Memorandum

To: Lisa Skumatz, Connecticut Energy Efficiency Board Evaluation Consultant
CC: Emily Rice, CT EEB Executive Secretary
From: Glenn Reed, CT EEB Technical Consultant
Date: May 11, 2023
Re: Technical Consultant comments on the 4/27/23 Draft for Project X1968 – RNC Baseline

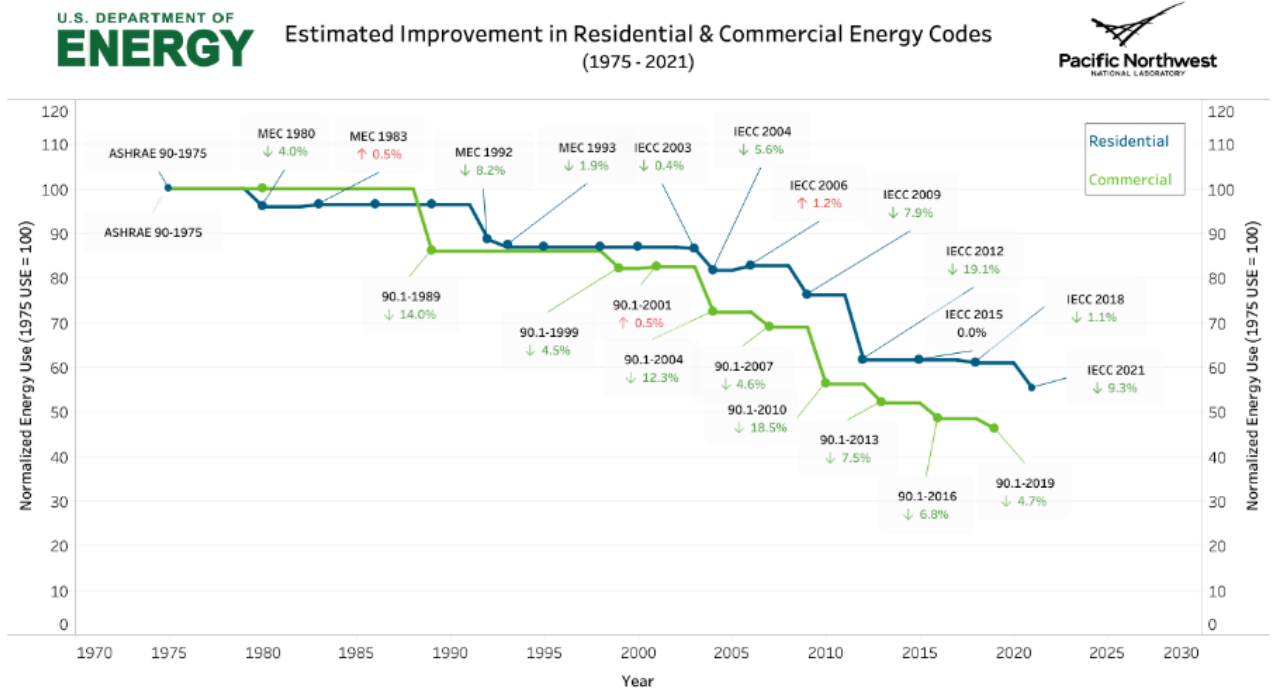
- The new code is based on 2021 IECC. Based on information from DOE [Infographics | Building Energy Codes Program](#) (see below) it appears that the new code will be considerably more stringent (about 10%) than 2015 IECC, which was the basis for the CT code in effect when the homes surveyed in this study were built.

- What specific building elements are responsible for this increased stringency?
 - What would be the average HERS rating for a surveyed home if it were built to the new code?

- How should consideration of the new code inform the UDRH, if at all?
- How should the new code inform the timing of the next baseline study?
